PUBLIC HEARINGS ITEM DESCRIPTION: Final Plat #03-18 by Badger Development Drive Business Center Sixth June 11, 2003 Planning Department Review: See attached staff report dated June 11, 2003 recommending appliance of the June 5, 2003 memorandum from Rochester 2. Construction of a 5 foot wide concrete sidewalk is required and 28th St. NW, as well as a 10 foot wide bituminous per Drive.	proval subject to the following mossessed and must be paid prior of the paid prior of the paid prior of the entire frontage destrian path along the entire frontage edestrian path along the entire edestrian path along the entire frontage edestrian path along the entire edestrian path along the edestr	Brent Svenby, Planner odifications/conditions: or to recording the final ent – GIS Division. es of Superior Dr. NW, re frontage of West Circ
PUBLIC HEARINGS ITEM DESCRIPTION: Final Plat #03-18 by Badger Developmen Drive Business Center Sixth June 11, 2003 Planning Department Review: See attached staff report dated June 11, 2003 recommending apple 1. A GIS Impact Fee and E911 Addressing Fee shall be assembled, per the June 5, 2003 memorandum from Rochester 2. Construction of a 5 foot wide concrete sidewalk i

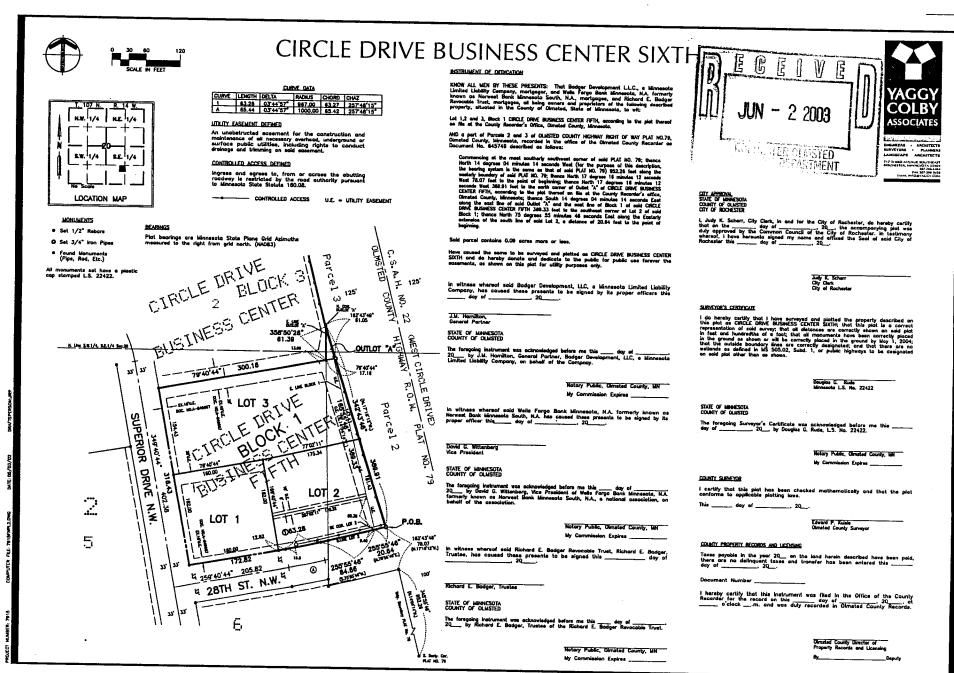
Pedestrian Facilities: Construction of a 5-foot wide concrete sidewalk is

required along the entire frontages of Superior Drive NW and 28th Street NW as well as a 10-foot wide bituminous pedestrian path along the entire frontage

of West Circle Drive.

- 2. Construction of a 5 foot wide concrete sidewalk is required along the entire frontages of Superior Dr. NW, and 28th St. NW, as well as a 10 foot wide bituminous pedestrian path along the entire frontage of West Circle Drive.
- 3. Storm water management must be provided. A Storm Water Management fee will be applicable at the time of individual lot development, if on-site detention is not provided.
